**UNION TOWNSHIP BOARD OF TRUSTEES  
JANUARY 9<sup>TH</sup>, 2024 MEETING**

**OVERLAY DISTRICT PLAN**

**CHARLES FRANCUS, Applicant  
1136 OLD STATE ROUTE 74**

***Staff Report: CASE # 13-23-O***

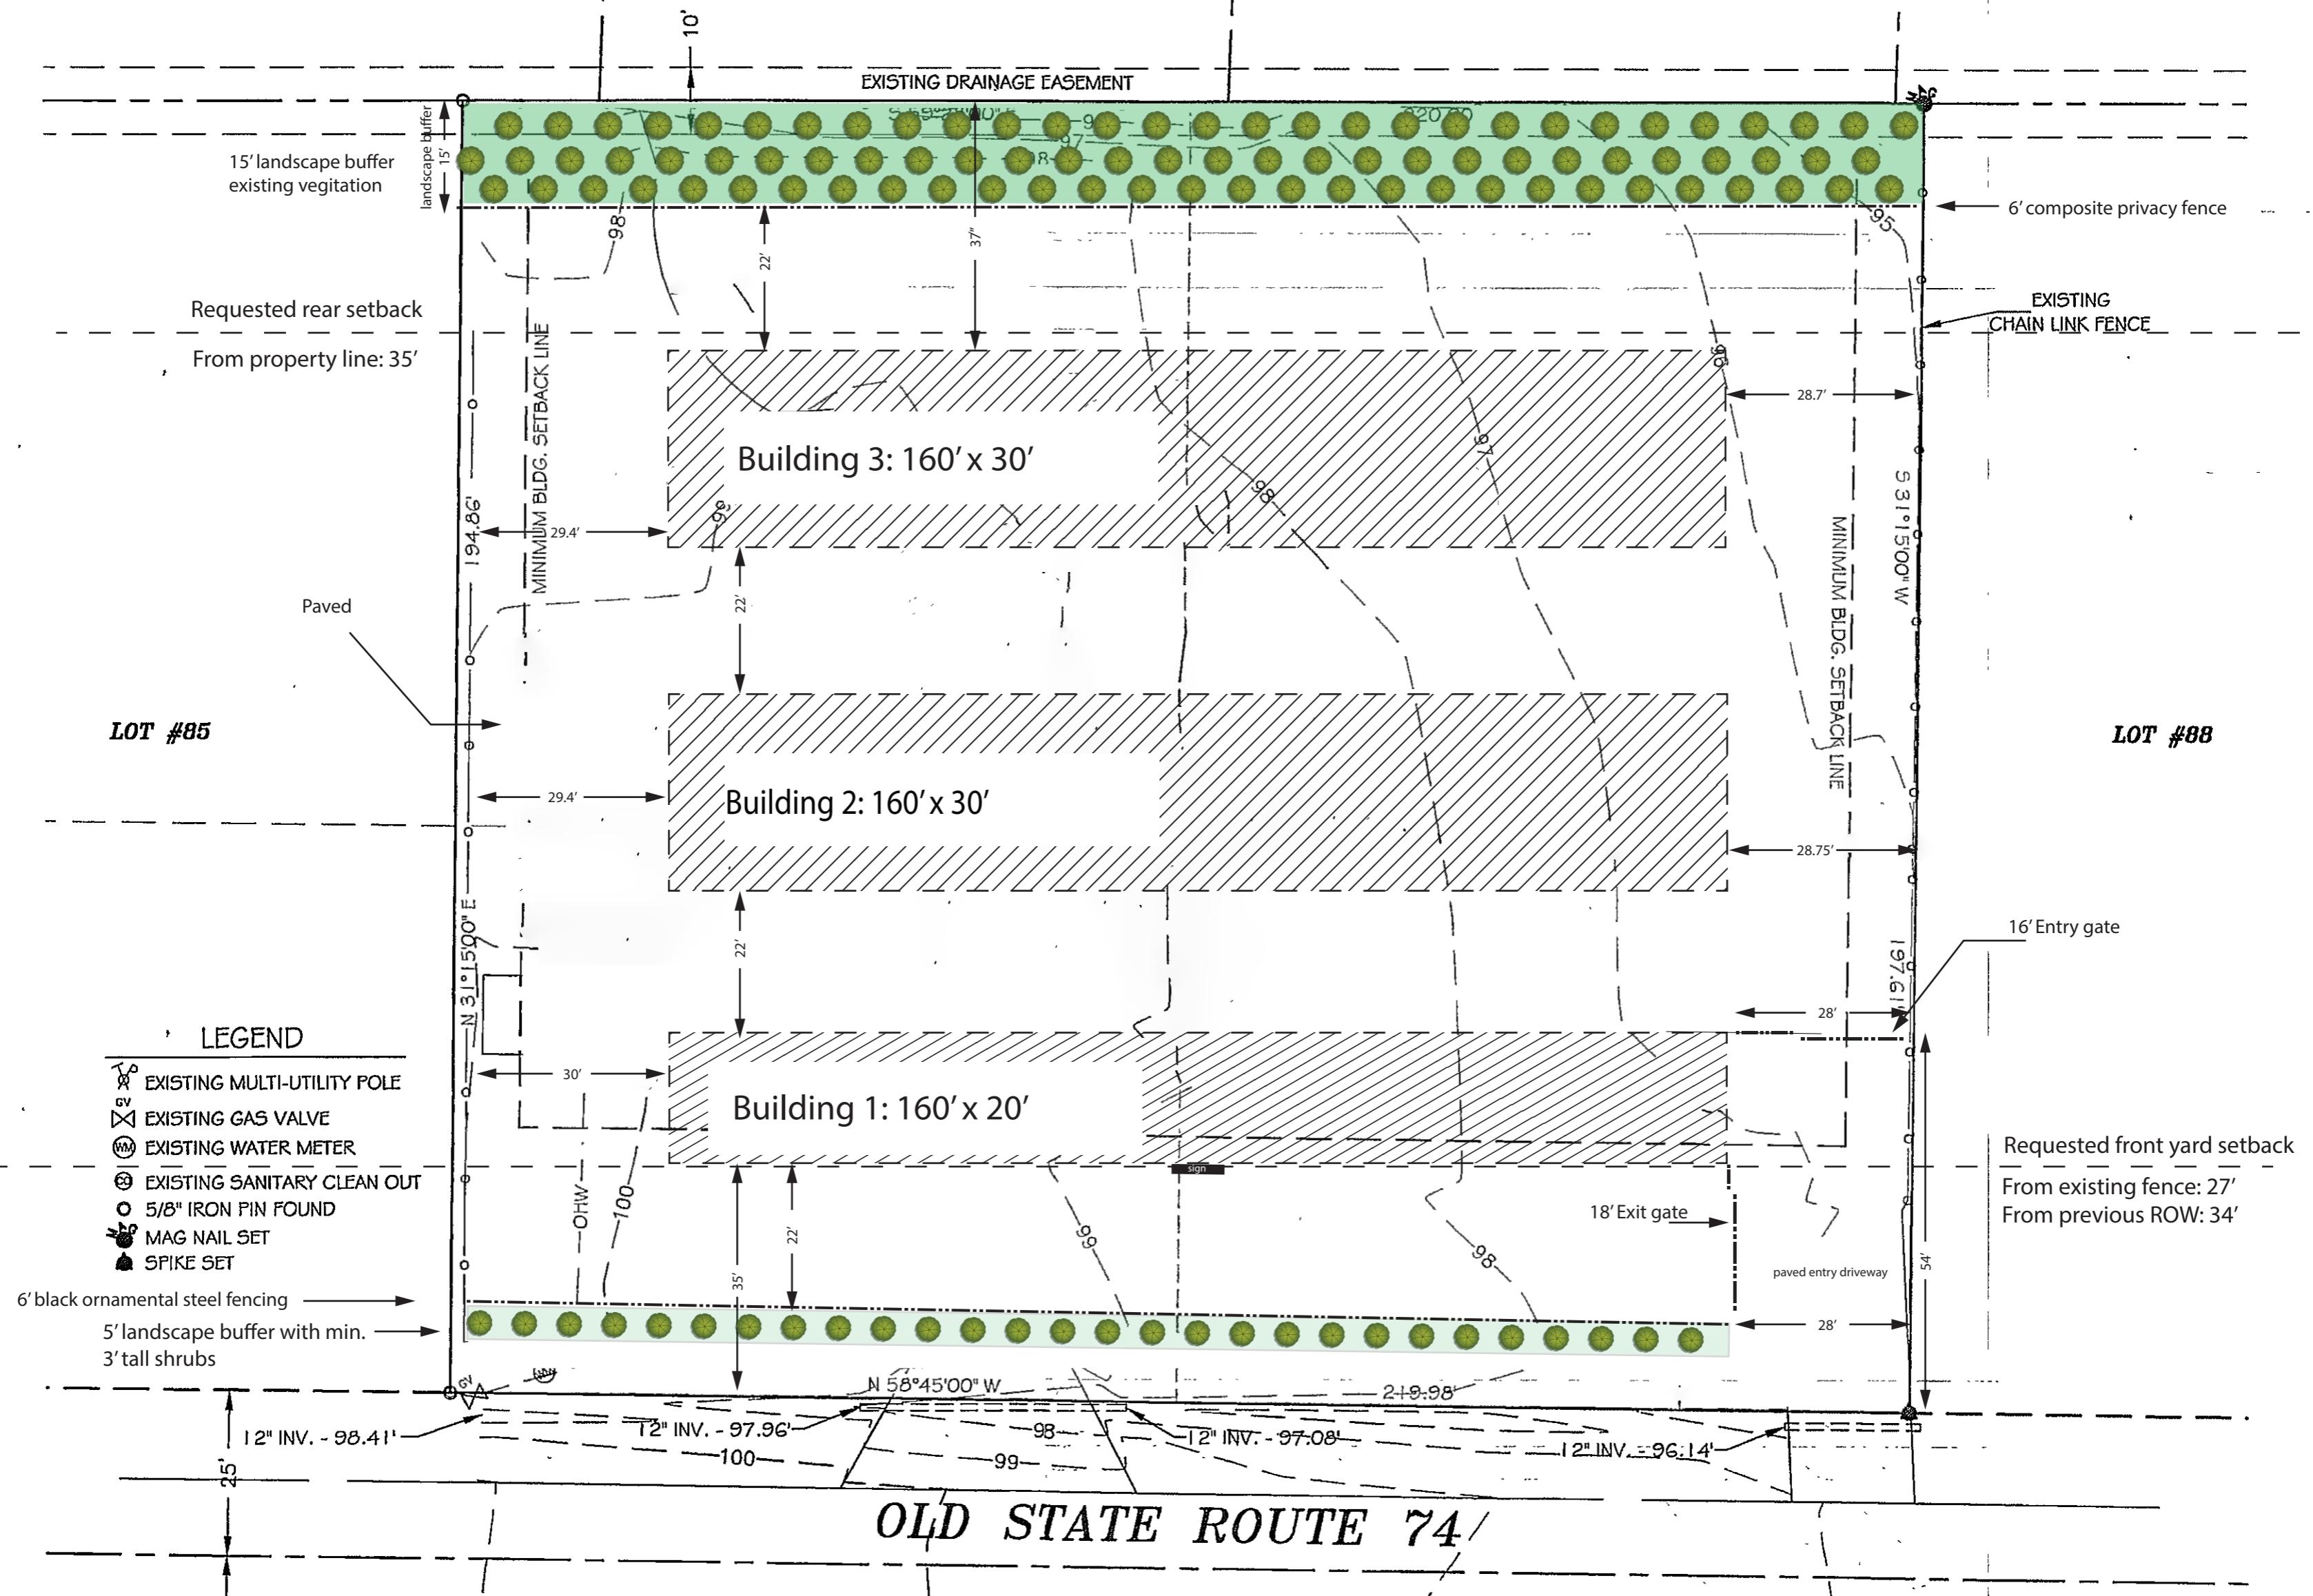
A review of the ‘preferred’ conceptual site plan indicates that there are three (3) single-story, self-drive-up storage unit buildings proposed for this property. The current application shows three (3) proposed structures being: 30 feet x 160 feet (rear), 30 feet x 180 feet (middle), and 20 feet x 140 feet (front). In total, the Applicant is requesting ~~13,000~~ **12,800** square feet of storage building space on the lot—*with the buildings reconfigured in consideration of the Township Fire Department’s review / comments. The proposed access and interior driveway areas would be paved.* As the current plan shows, front yard setback relief would be needed, with the proposed front structure being located approximately 27 feet away from the front property line—*instead of the required 40-foot front yard setback.* Although the property to the rear of this site is zoned Business (B-1), it is being used for multi-family residential purposes. Therefore, rear yard setback relief would also be needed as the proposed rear building is shown on the current plan as being located approximately 35 feet away from the rear property line—*instead of the required 100-foot front yard setback. The majority of the proposed visible building faces, as seen from Old State Route 74, would be red brick—as shown in the Applicant’s renderings—which would meet or exceed the Township’s requirements regarding the use of high-quality, traditional building materials* (as set forth in the Zoning Resolution and Comprehensive Plan for this particular Corridor). *Proposed signage information has been submitted (as far as the proposed location, look and materials of the signage) and a landscaping / buffer yard plan has been submitted—with the number of burning bushes in the front yard to be determined based on the spacing of the proposed plantings.* Finally, there has been no lighting plan submitted; however, the Applicant has noted that the proposed facility will feature solar lighting.

***Additionally, the Applicant has withdrawn an ‘alternative’ conceptual site plan to request an increased intensity to the pre-existing, non-conforming outside storage use on the property.***

- 2) The Applicant would need to provide a more detailed landscaping plan—including the final number of proposed plantings in the front yard. Additionally, all *existing* landscaping to remain and proposed landscaping should be marked as preservation area(s), and any vegetation disturbed should be repaired, supplemented, or replaced. *This is an item that can be addressed administratively by staff.*

- 4) A photometric / site lighting plan would ultimately need to be submitted. All lighting would also need to be noted as being downward directed, and of sufficient intensity to illuminate without projecting onto the adjoining property. \*Details / specs of proposed lighting would be necessary. *This is an item that could be addressed administratively by staff.*
